Technical Service Bulletin: TSB250118

Released Date: 07-Jul-2025

Obsoleting the Re-use Criteria for Crankshaft Adapter Capscrews

Figure 1, Crankshaft Adapter Capscrews.

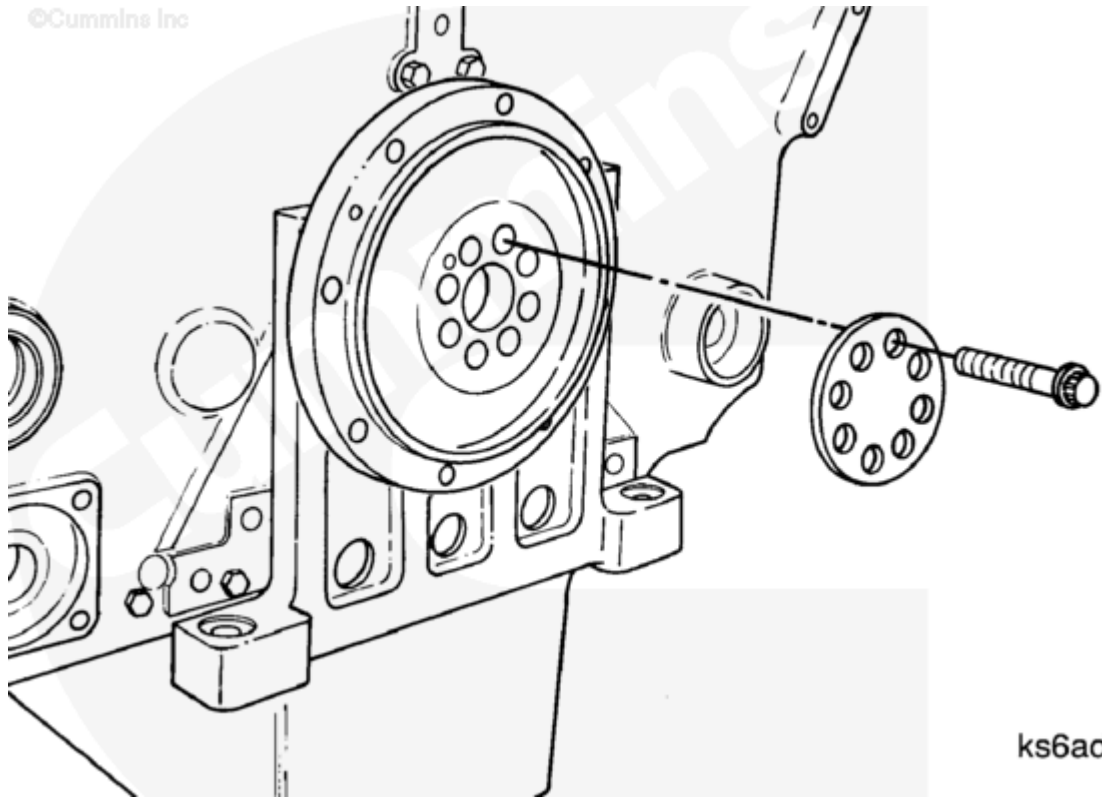
- Crankshaft adapter capscrews have been found broken upon inspection and during engine rebuilds.

- **Always** replace crankshaft adapter capscrews during rebuilds and mid-life events.
